**RE: NCR's October 3, 1996 Inspection Exit Meeting Comments
Bluewater Uranium Mill Site, License No. SUA-1470, Docket No. 40-8902**

Responses to the NRC's October 3, 1996
Inspection Site Exit Meeting Comments

Figure AD2-1 NRC Soil Sample Locations (Sampled 10/03/96)

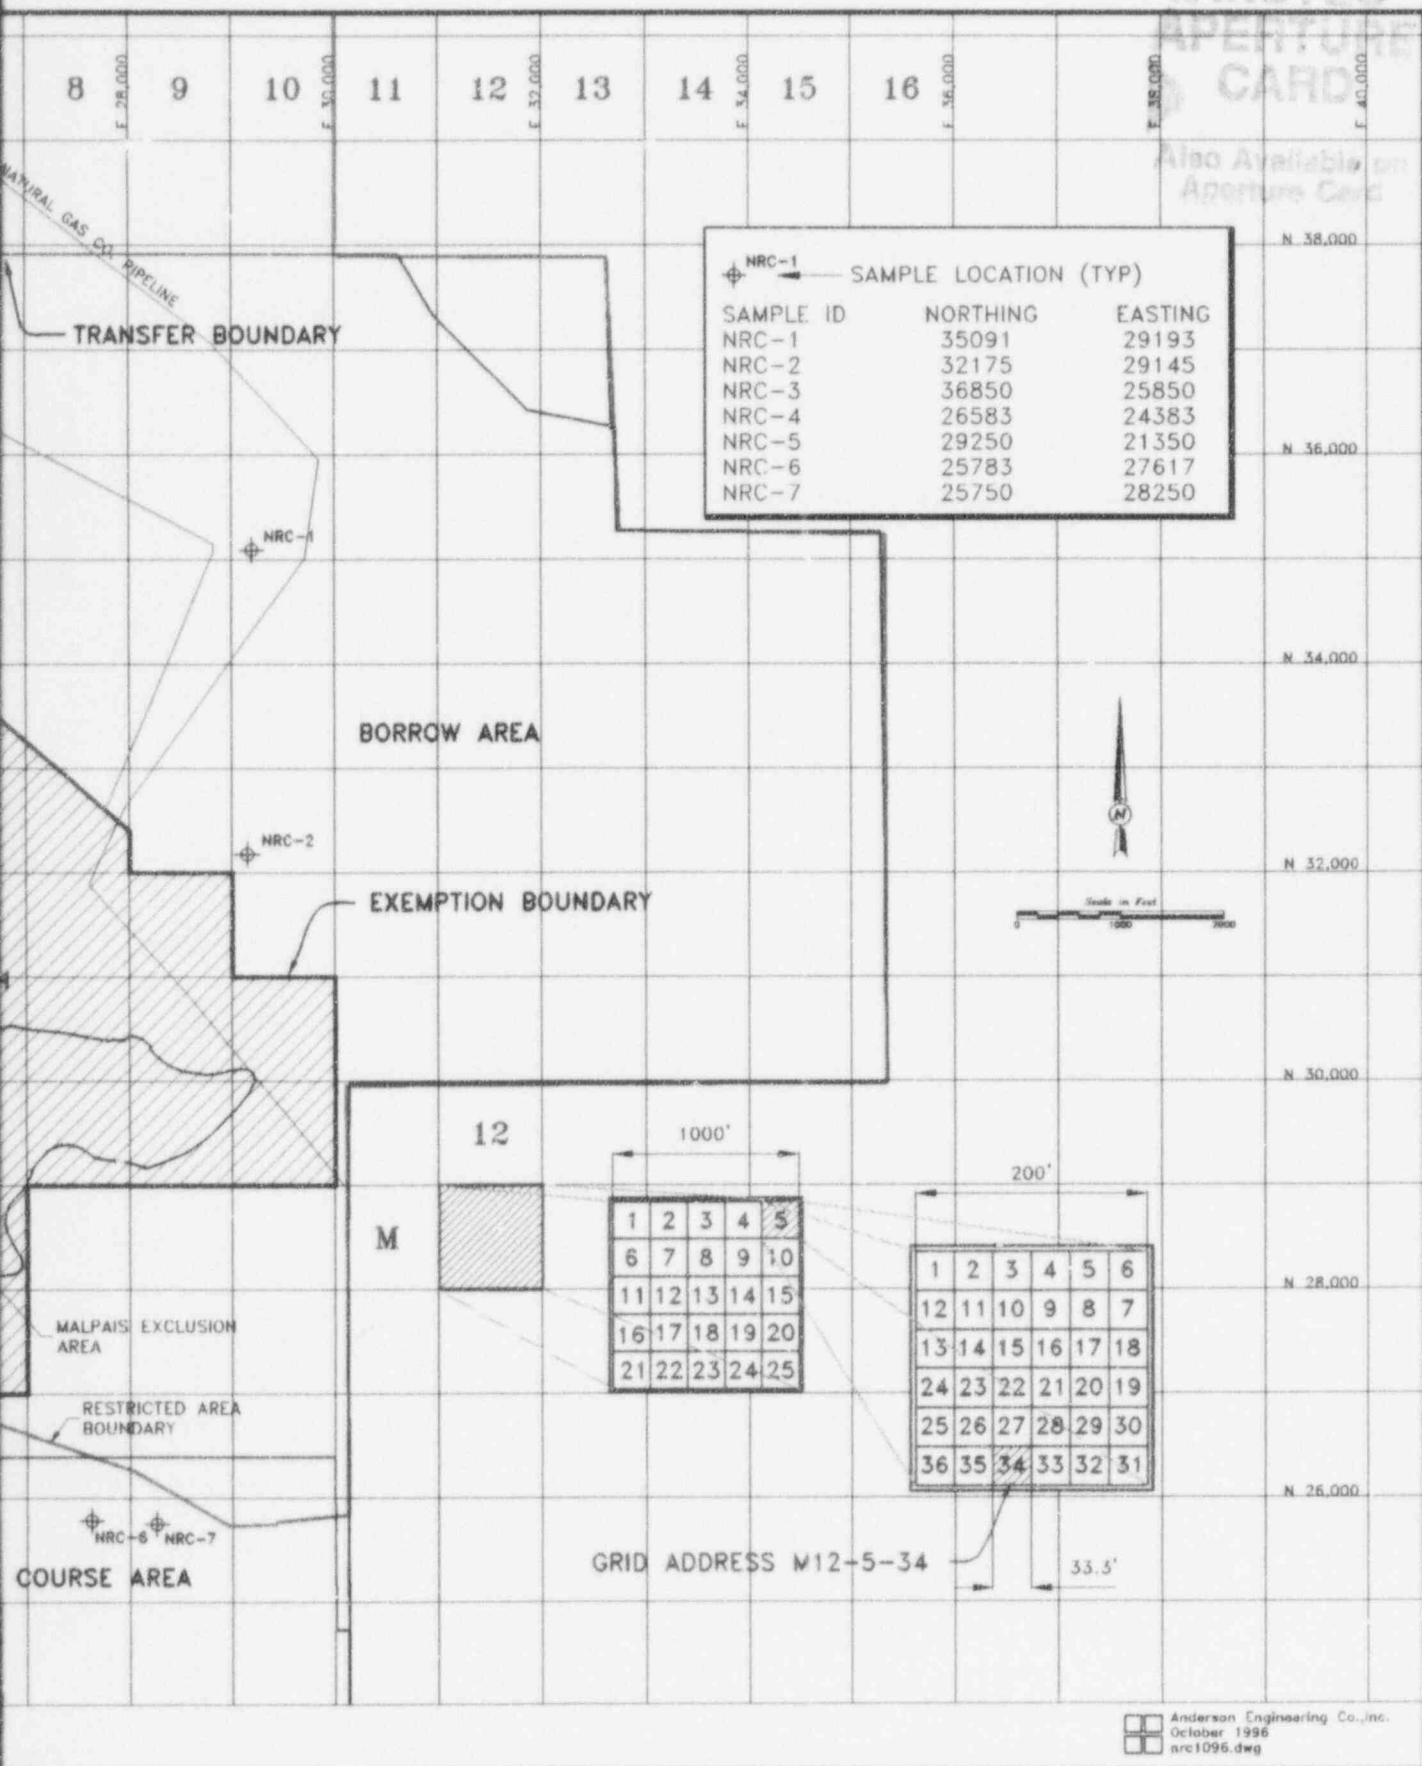
Please provide a map showing NRC's October 3, 1996 sampling locations at the Bluewater Mill Site.

Map AD2-1, showing the sampling locations is attached with this response.
